Access Compliance Report

Public Rights-of-Way

(Curb Ramps)

| Intersection ID: 2454 | Main Street: CLARKE_CREEK_PY | Cross Street: MILLSTREAM_RIDGE_DR | Location: SE |

| ADA ID: 0E637565D398 | Ramp Type: PerpDiag | Initial Pass/Fail: Fail | Overall Compliance: No |

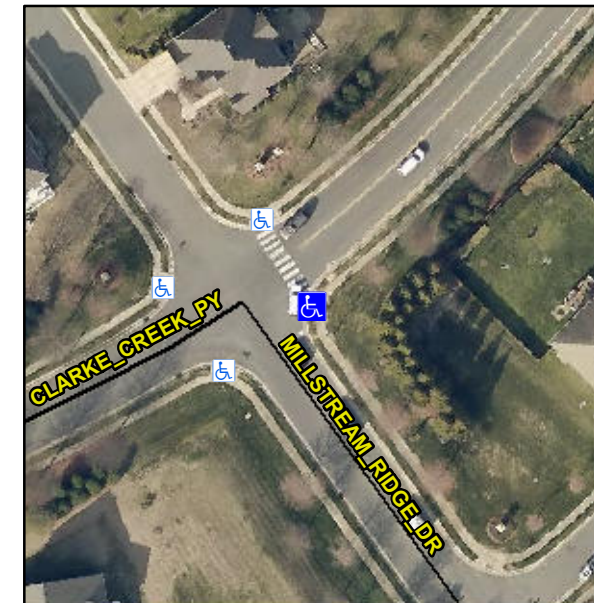
Not Found, R304.5.1

| Compliance | Description | Data | Compliance | Description | Data |
|------------|-----------------------|-------|------------|-----------------------------|------|
| No | Ramp Width (in) | 42.0 | Yes | Ramp XSlope (%) | 0.2 |

Remove & Replace Curb Ramp With Two New Directional Ramps or Equivalent.
